**Draft Final Decision Document
for the Basin A Neck Groundwater Intercept
and Treatment System Interim Response Action
at the Rocky Mountain Arsenal**

December 1988

COMMENTS ON THE PROPOSED DECISION DOCUMENT
FOR THE INTERIM RESPONSE ACTION FOR
BASIN A NECK GROUNDWATER INTERCEPT AND TREATMENT SYSTEM
SEPTEMBER, 1988

RESPONSES TO COMMENTS BY THE U.S. ENVIRONMENTAL
PROTECTION AGENCY, REGION VIII, ON THE PROPOSED DECISION
DOCUMENT FOR THE INTERIM RESPONSE ACTION FOR THE
BASIN A NECK GROUNDWATER INTERCEPT AND TREATMENT SYSTEM
SEPTEMBER, 1988

Figure 5.
Saturated Alluvial Thickness
in the
Basin A Neck Area

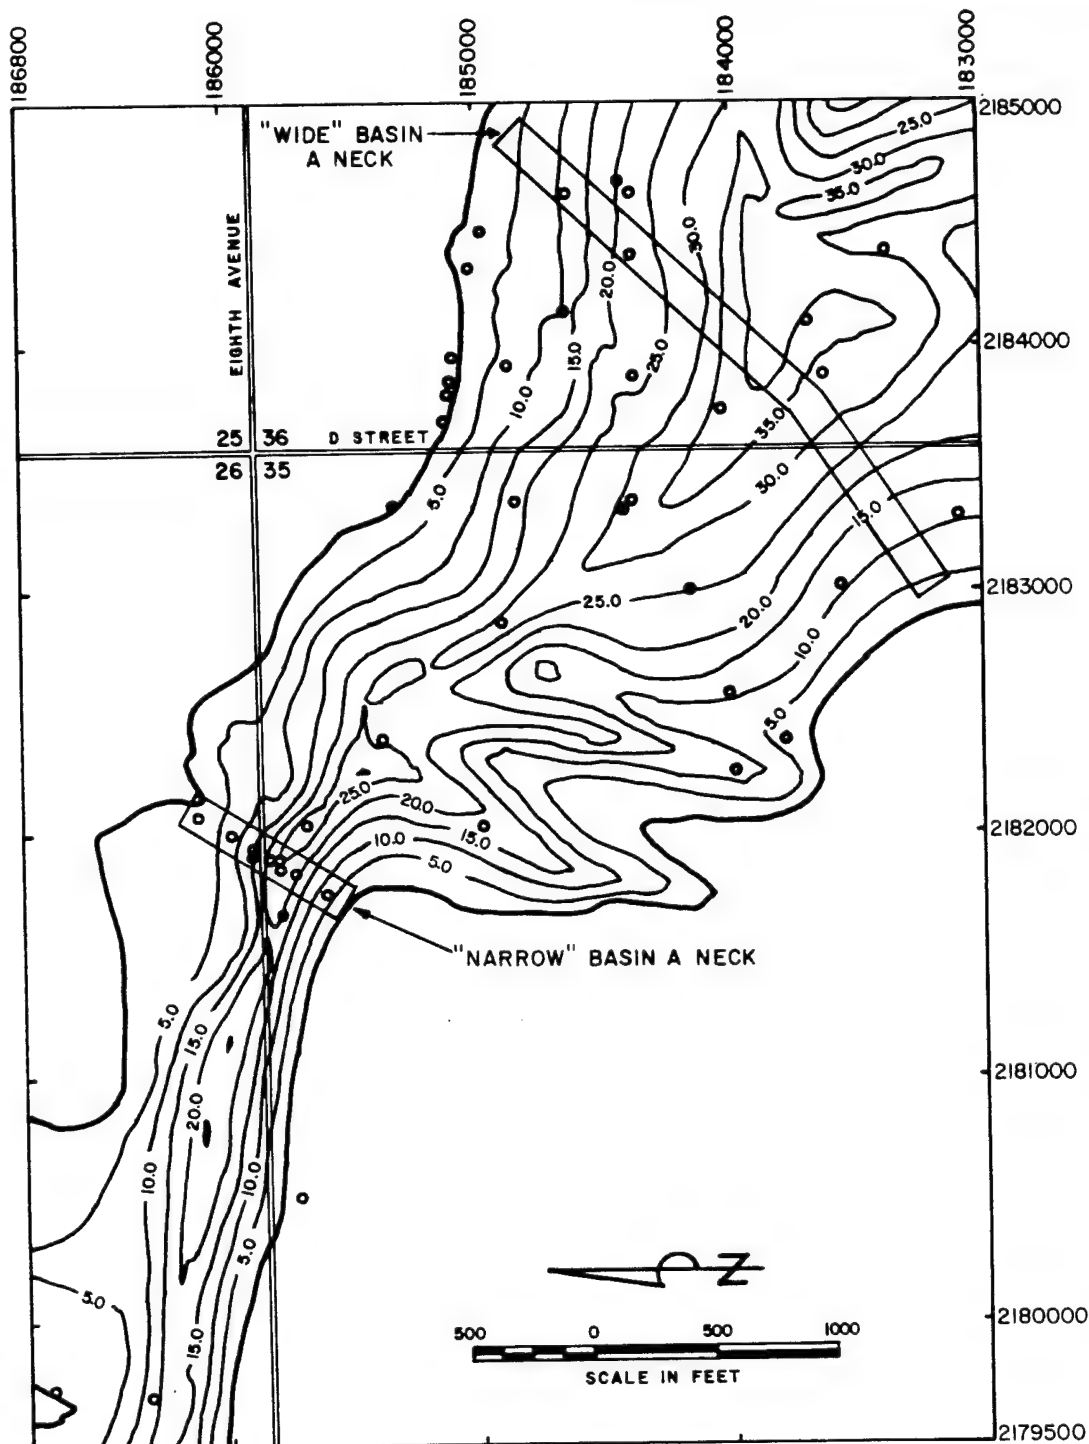
3. Further characterization of the Basin A neck hydrology and contaminant distribution is needed prior to the selection of the exact location for the system. Four important aspects of a more detailed siting study need to be considered and addressed in the Decision Document. First, the location of the intercept system downgradient of subcropping Denver sand units may result in increased capture of flux being discharged from the Denver units. Second, locating the system closer to the sources (i.e. South Plants area) could result in capturing more contaminants before they migrate into the underlying Denver formation. However, by locating the intercept system upgradient of the "neck" (toward Section 1), the desirable constriction occurring at the "neck" would be lost. Third, the faults and/or fault zones appear to affect the shallow aquifer flow and may affect the operation of the extraction and/or injection systems. Fourth, the northeast Denver sand conduit may have a significant affect on the flow and contaminant movement in the shallow aquifer. These aspects should be investigated and addressed in the Decision Document to assure the optimal site for the system.

Response: As shown on Figure 5, the width of the saturated alluvium in the area of the "wide" Basin A Neck is approximately 2800 feet. Such a statement has been incorporated in the text.
